PHILIPPINE HEART CENTER
East Avenue, Quezon City

SUPPLEMENTAL BID BULLETIN No. 079 -2022

SUBJECT : Modifications/Amendments in the Bidding Documents

PROJECT/S : 3 units Automated Instrument Washer - ITB No. 105.22

A AREA OF INSTALLATION

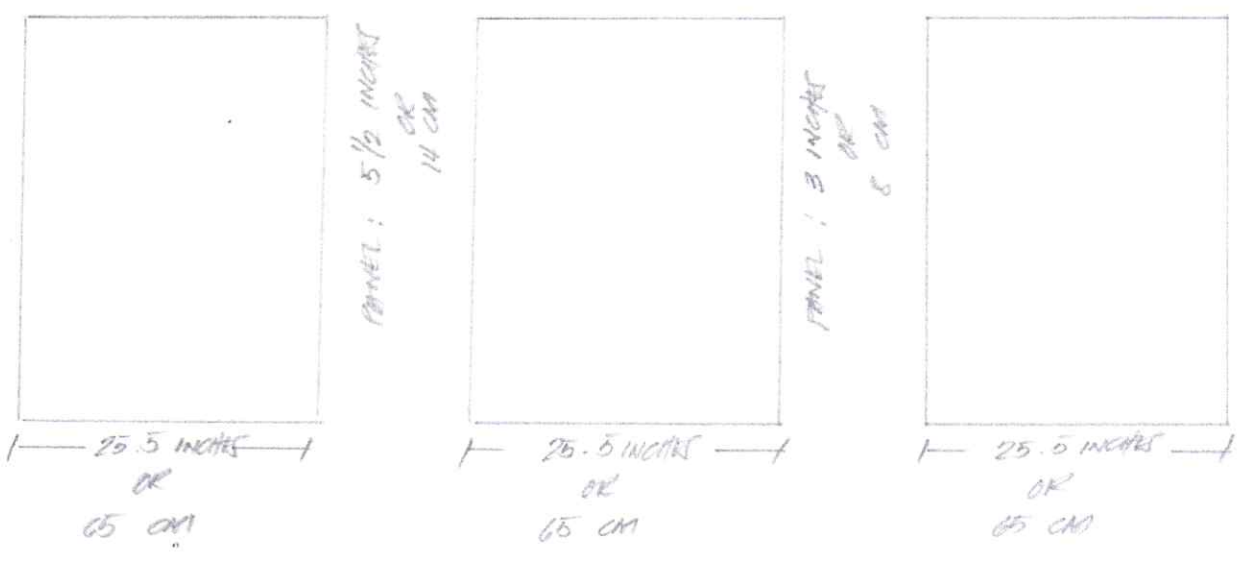
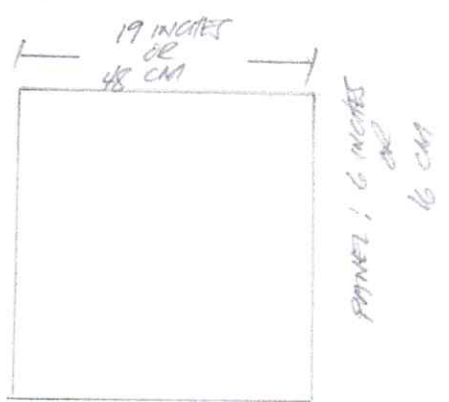
1.1.3. Automatic sliding door, with downward vertical movement	To be deleted
38	1.6. Chamber size and shape 1.6.1. Chamber/Internal working dimension: 550-590 (L) x 555-620 (W) x 625-685 (H)mm	1.6. Chamber size and shape 1.6.1. Chamber/Internal working dimension: 550-590 (L or D) x 555-620 (W) x 625-685 (H)mm
		For Inclusion: - External dimension must fit the area of installation - Please see attached Diagram
